Addendum 01

DATE: January 28, 2026

PROJECT: Upper Scioto Valley Ambulance District
12231 State Route 235
Harrod, Ohio 45850

PROJECT #: 25023.00

SHEET NUMBER:
A1.1

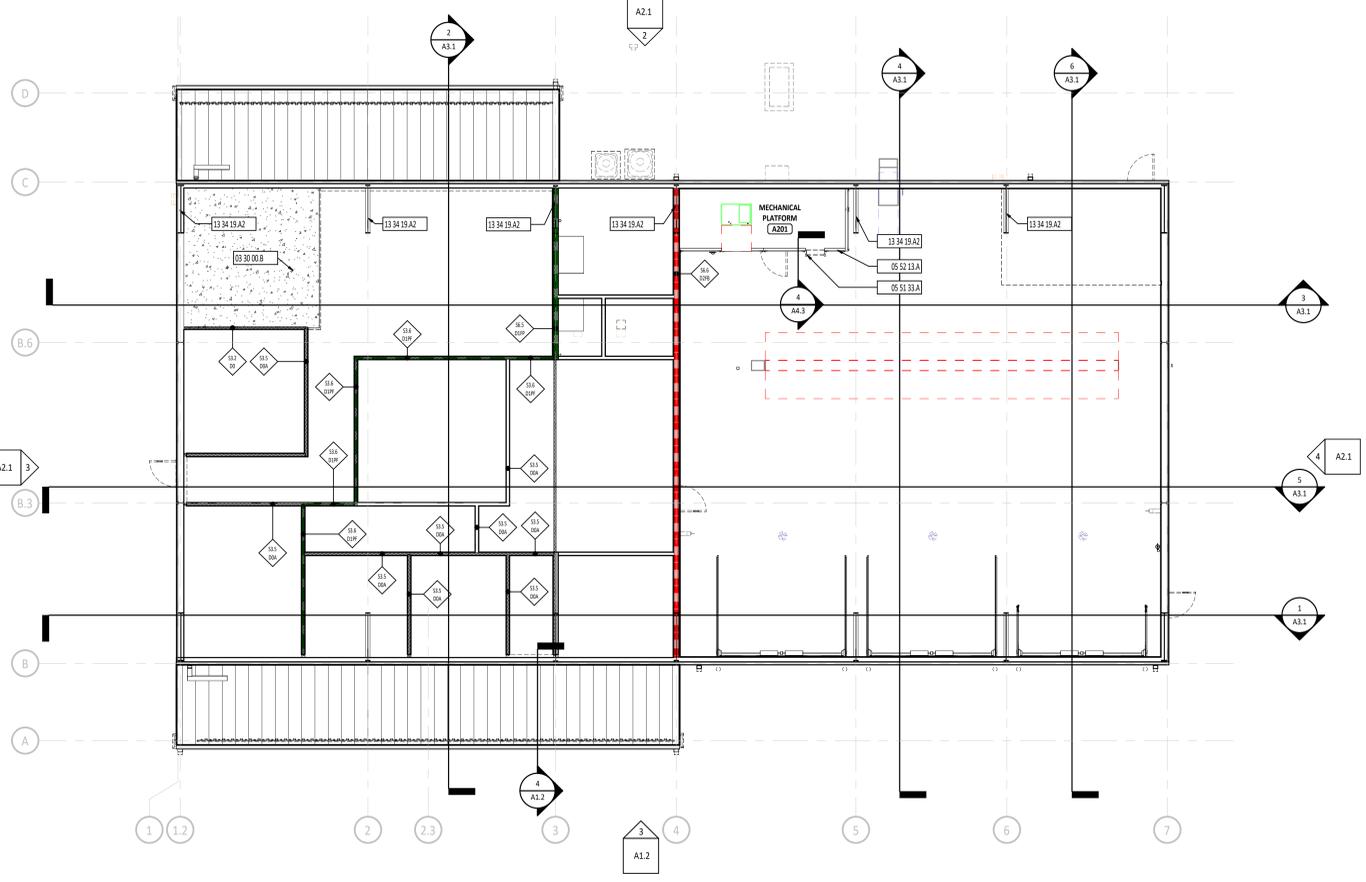
1. Drawing Sheet A1.1 First Floor Plan: Removed keynote 13 34 19.A31 Mezzanine Support Column – Location Determined by PEMB Manufacturer. No mezzanine columns to be included.
2. Drawing Sheet A6.1 Door Schedule and Details: Revised details 5 and 9
3. Drawing Sheet C2.0 Grading Plan: Add note: The contractor is to excavate, then compact the pond to ensure it's sealed. No clay liner is needed

4. Please Reference Drawing # A1.1
Please clarify if the four (4) mezzanine support columns shown on Drawing A1.1 are not required and can be deleted from the bid documents.
 - a. **Response: All mezzanine support columns are to be removed from the drawings. Updated drawing sheet A1.1 will be issued to reflect these changes.**
